COMMISSION OF ARCHITECTURAL REVIEW STAFF REPORT August 28, 2018 Meeting

9. **COA-039802-2018** (L. Lefferts)

2708-2712 East Broad Street St. Johns Old and Historic District

Project Description: Install exterior gutters along the porch cornice and downspouts on the outer bays.

2708 East Broad Street, Assessor Photograph, date unknown.

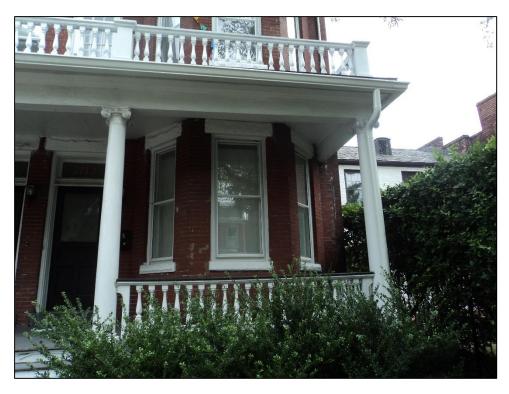
The new gutters appear to be vinyl with plastic downspouts and are installed directly below the porch roof cornice line. The gutters project past the cornice line at either end of the porch roof. At the outer bay of 2712 East Broad a downspout was installed on the front of the outermost column.

The *Guidelines* note that repair (pg. 91, #3) including membrane lining (pg. 66#8) should be undertaken as part of preventative maintenance. Based the profile of the porch roof, Staff believes that box gutters might be present on the porch roof. The *Guidelines* recommend that leaky box gutters should be lined with membrane roof (pg 66, #8). Staff recommends that if box gutters are present, they should be repaired, including lining with a membrane, and the newly installed exterior gutters be removed.

The Guidelines also state that suspended gutters should be attached at the eaves with spikes or straps and that the straps should be fastened under roofing materials not on the roof surface (pg. 66, #9). Staff recommends that if box gutters are not present that the current gutters be replaced with a less visually intrusive model, such as a half round, and that the downspout and gutter on the column of the outer bay of 2712 East Broad Street be moved to a less visible location.
